Model: PRIPORT Platinum/Platinum P/Platinum2		Date: 3-Sep-08	No: R-C267-001e
Subject: Firmware Modification History		Prepared by: K. Yamamoto, Priport Service Planning Section	
Classification:	<input type="checkbox"/> Troubleshooting <input type="checkbox"/> Part information <input type="checkbox"/> Action required <input type="checkbox"/> Mechanical <input type="checkbox"/> Electrical <input type="checkbox"/> Service manual revision <input type="checkbox"/> Paper path <input type="checkbox"/> Transmit/receive <input type="checkbox"/> Retrofit information <input checked="" type="checkbox"/> Other ()		
Model Name: Platinum: Ricoh DX3340/DX3440C/DX3240, Gestetner CP6146/DX3440/CP6300C/DX3240, Savin 3180DNP, Lanier LDD120, RexRotary DX3440/DX3240, nashuatec DX3440/DX3240, Standard SD360 Platinum P (China only): Ricoh DX3440CP, Gestetner CP6300P Platinum 2: Ricoh DX3442/DX3442C/DX3242, Gestetner DX3442/CP6301C/DX3242, Rotary DX3442/DX3242, nashuatec DX3442/DX3242

FIRMWARE MODIFICATION HISTORY

Model: PRIPORT Platinum/Platinum P		Date: 23-Oct-06	No: R-C267-002
Subject: Durability of the cloth screen is not enough		Prepared by: K. Yamamoto, Priport Service Planning Section	
Classificati

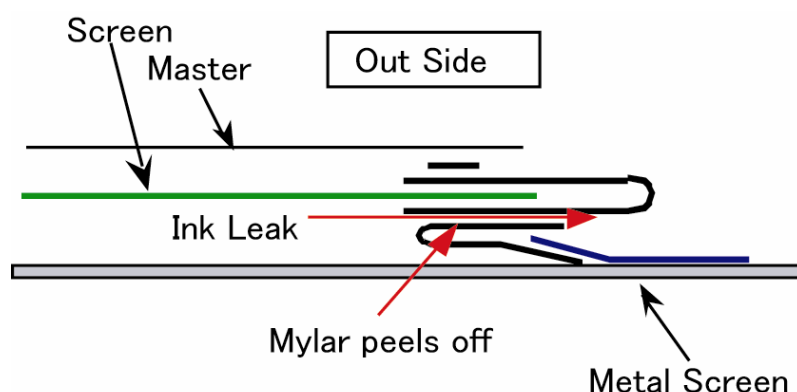
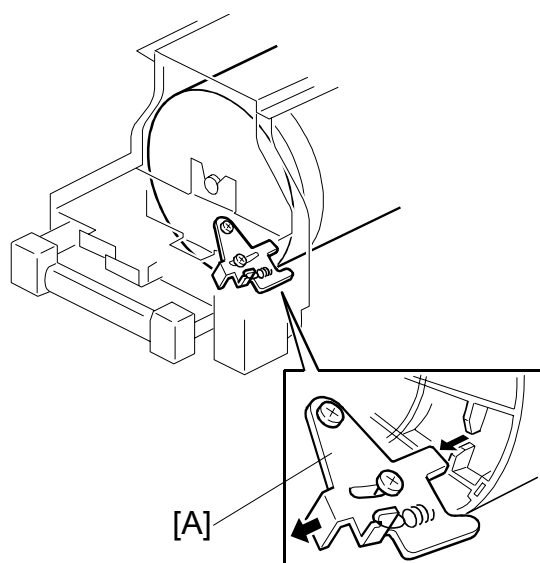
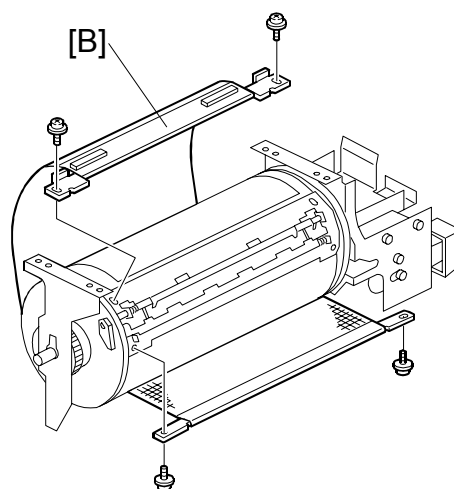
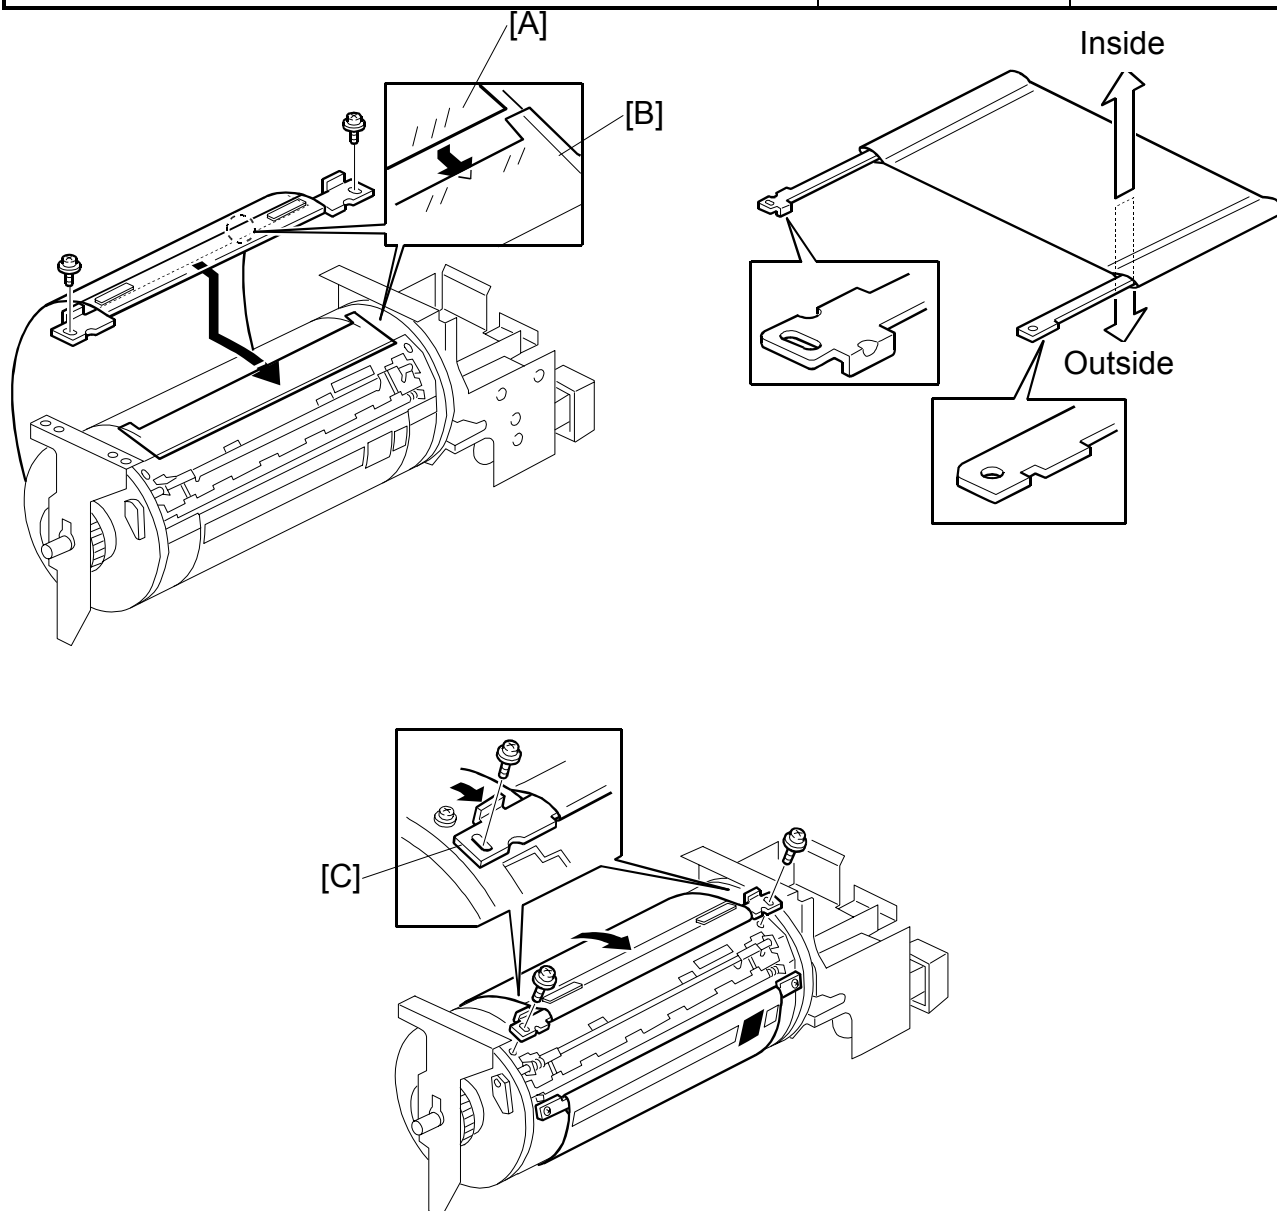
The ink leaks from the trailing edge of the cloth screen on the black drum.

The Mylar peels off the cloth screen during printing, causing the ink to leak from between the Mylar and cloth screen.

The cloth screen for the black drum was changed to the one that is used on optional drums.

Size	Old	New
B4	C2672335	C2522340
LG	C2672336	C2522341
A4	C2672337	C2522342

1. Remove the drum upper bracket (⌘ x 4).
2. Release the stopper [A], then rotate the drum until the master clamber faces top.
3. Remove the cloth screen [B] (⌘ x 4).

- Do not scratch the cloth screen and metal screen.
- Properly insert the edge of the cloth screen [A] under the mylar [B] on the metal screen, as shown above.
Otherwise, ink will leak from the trailing edge of the master on the drum during a long printing run.
- Make sure that the correct side of the screen is facing up. In addition, make sure that the stays for securing the cloth screen are positioned correctly.
- When replacing the cloth screen, spread the screen around the metal screen while pulling the stay [C]. Adjust the stay so that it is parallel to the master clumper, then tighten the screws.
- Make sure that the cloth screen is not wrinkled while spreading it around the drum.

INSTALLATION PROCEDURE FOR THE MYLAR

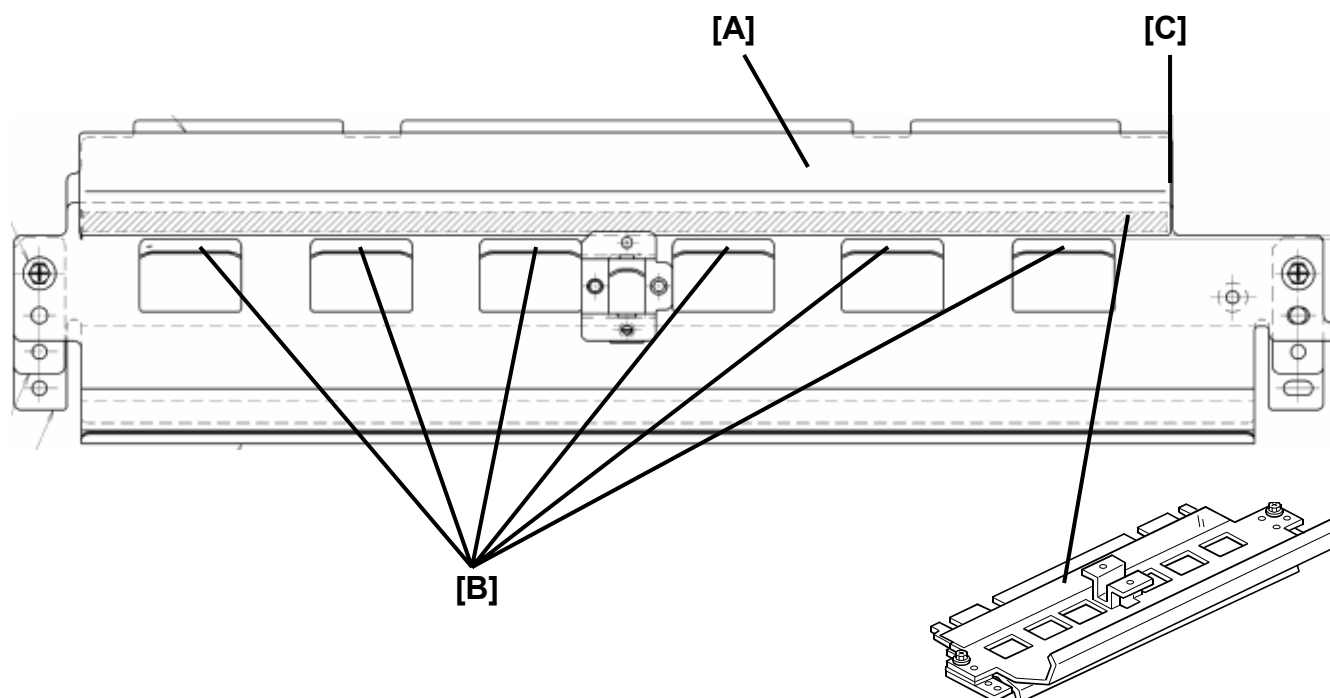
- Use paper that satisfies the paper weight requirements specified above.
- Decrease the printing speed.
Note: The printing speed should be 80 sheets/minute for thin paper that is less than 52.5g/m².
- Try different combinations of the above two actions, as the results can also depend on environmental conditions and specific paper type.
- Replace the paper guide Mylar.
Note: See below for the **Installation Procedure**, and **MB #MC267008** for the parts number information.

1. Remove the drum.
2. Open the master eject unit carefully.
3. Remove the old Mylar.
4. Clean the paper feed guide [A] and remove the glue.

1. Align the edge of the Mylar with the bumps [B], as shown above.
2. Make sure that the edge of Mylar is aligned with the edge of the guide [C].
3. The attachment position is the same for both the old and new Mylars.

3.Color Drum 3 (C647/C648)

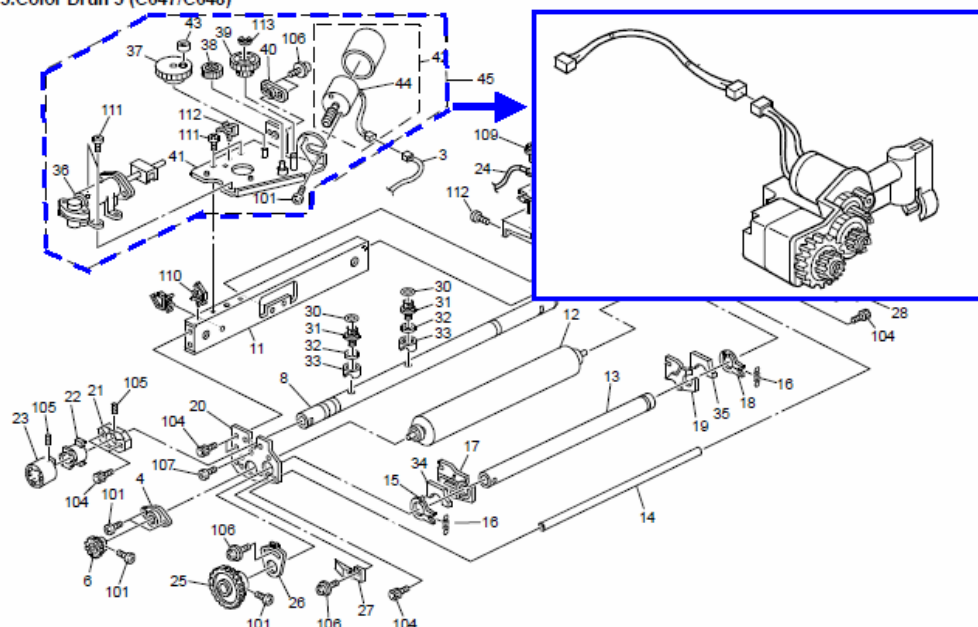
- **Main change:** The Ink pump unit was changed to the same Thorochoid unit used on the PT series and TT3.
Reason: To facilitate servicing in the field.

- **In accordance with this change:**
 - Some service parts changes were made (**see the PT or TT3 parts catalog**).
 - The format of the serial number for the drum was changed (**see the table below**) so that it is easy to distinguish between the drums with the old/new pump units.

17.VACUUME FAN UNIT (C267)

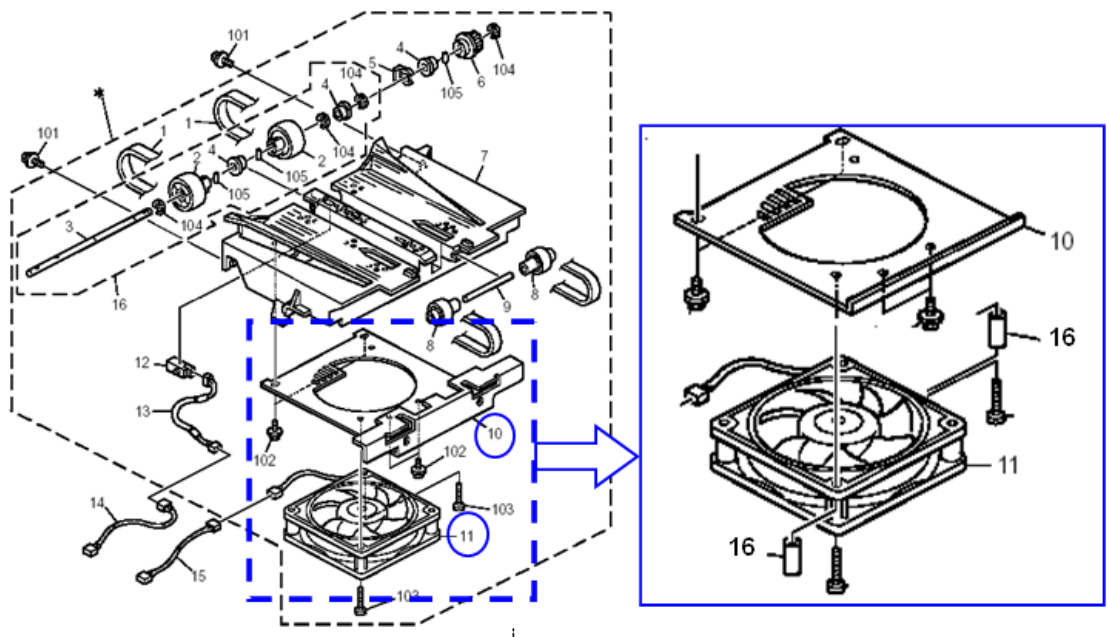
Change/Reason: Parts standardization with new model PT3.

Old #	New #	Description	Qty	Int	Page	Index
C2673804	C2713804	HALE UNIT:ASS'Y	1	X/O	41	*
C2615880	AX655800	DC FAN MOTOR:AXIAL:MM119:24V	1	X/O	41	11
C2673801	C2753801	STAY:PAPER EXIT SUB-UNIT:ASS'Y	1	as a set	41	10
	C2725887	SPACER:DC FAN MOTOR:AXIAL:MM119:24V	2		41	16

10.PROTTER UNIT 1 (C267)

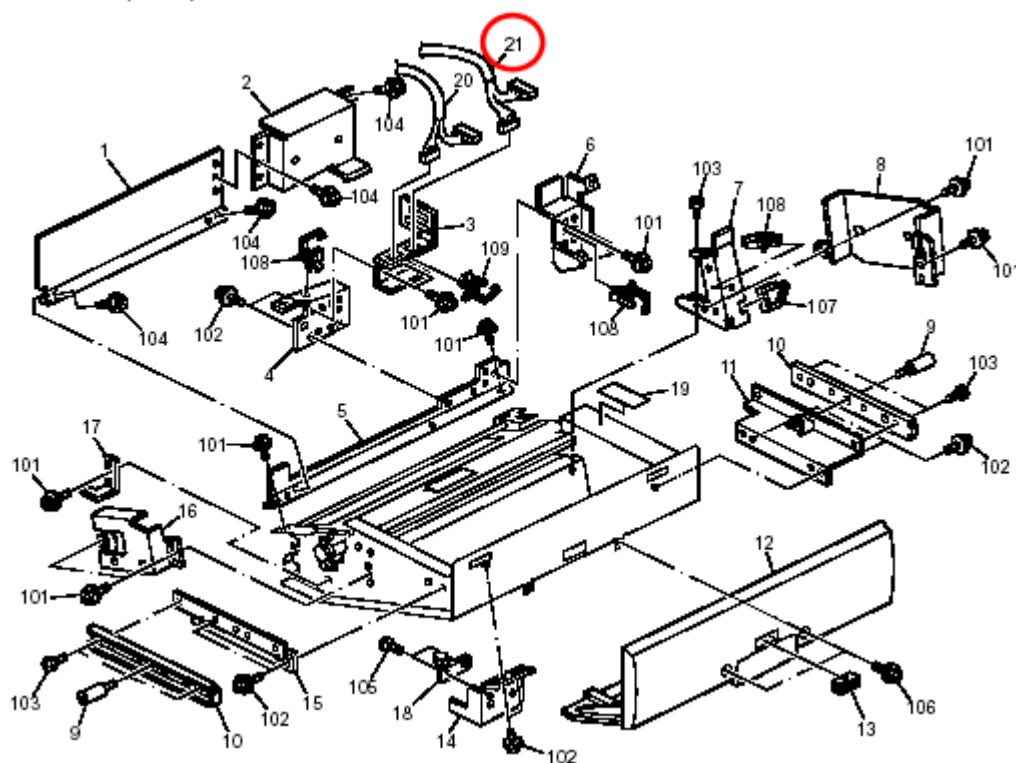
Change/Reason: The harness circled in red was changed to standardize parts with Model PT3 (C275).

Old part number	New part number	Description	Q'ty	Int	Page	Index	Note
C2675244	C2755244	HARNESS:CONNECTING:PLOTTER:2:ASS'Y	1	X/O As a Set	27	21	
	C2755245	HARNESS:CONNECTING:CUTTER UNIT:ASS'Y	1		27	22*

21.ELECTRICAL SECTION 1 (C267)

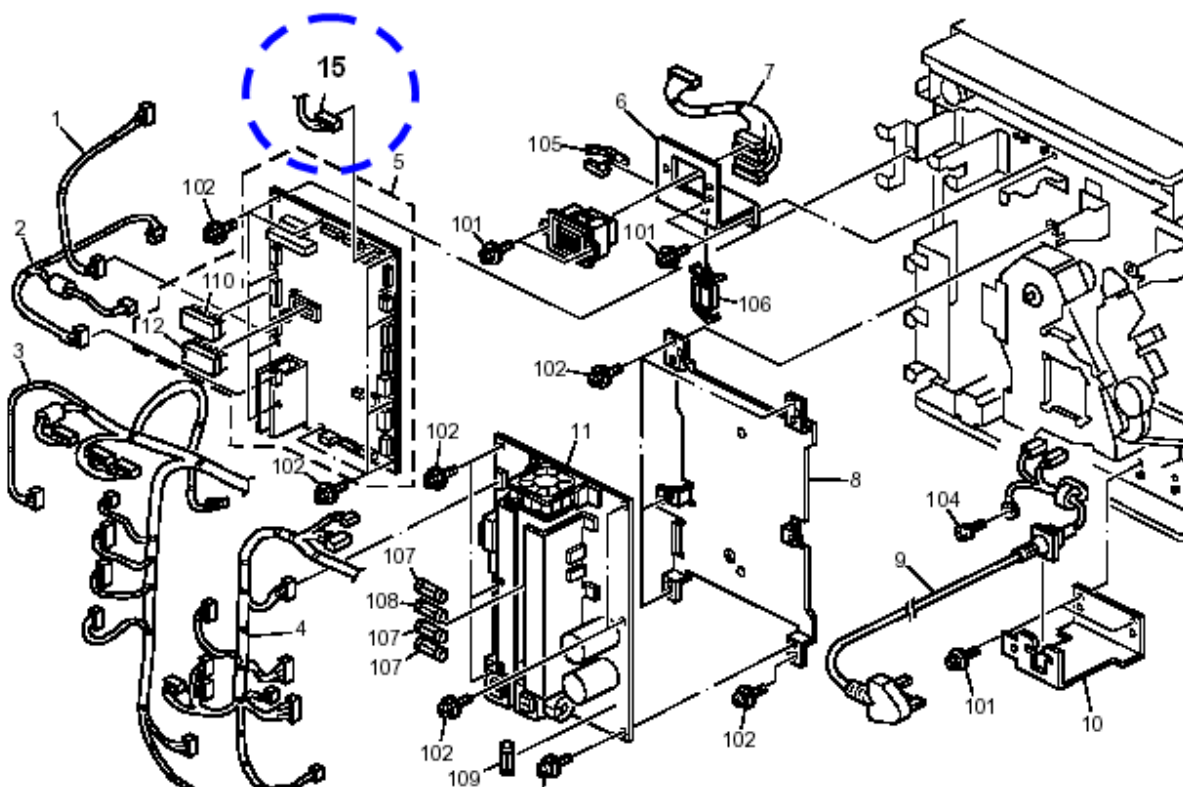
Old part number	New part number	Description	Q'ty	Int	Page	Index	Note
	C2755206	HARNESS:INK:ASS'Y	1		49	15*

Change/Reason: The harness was missing from the Parts Catalog.

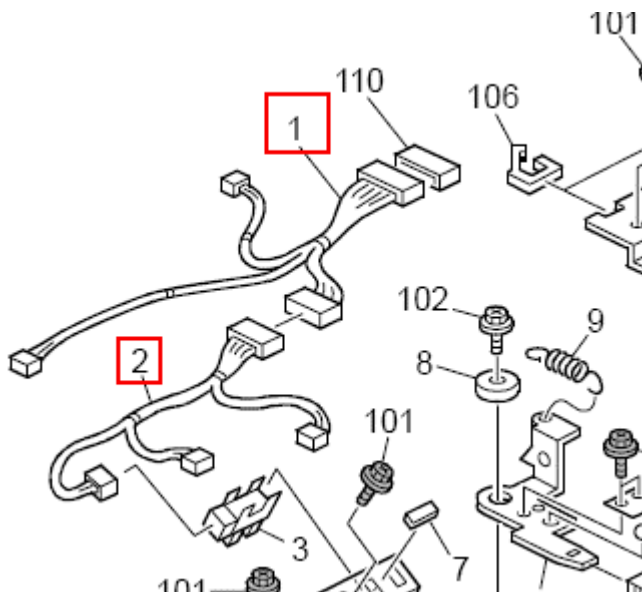
Change / Reason: The following part indexes in the parts catalog were corrected.

Old part number	Description	Q'ty	Page	Incorrect Index	Correct Index	Note
C2675273	HARNESS:CONNECTING:STAY:P LOTTER:ASS'Y	1-1	23	4	2	
C2675272	HARNESS:STAY:ASS'Y	1-1	23	2	1

16.DRUM UNIT 3 (C267)

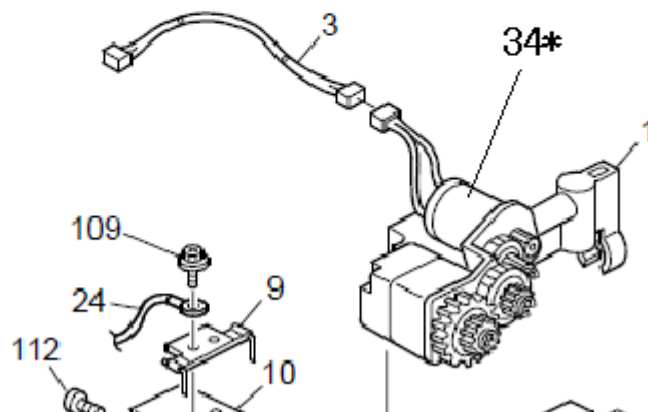
Old part number	New part number	Description	Q'ty	Int	Page	Index	Note
-	C2672427	DC MOTOR:PUMP UNIT	1	-	39	34*

Change: The DC pump motor was added as a service part.

Reason: To improve serviceability in the field.
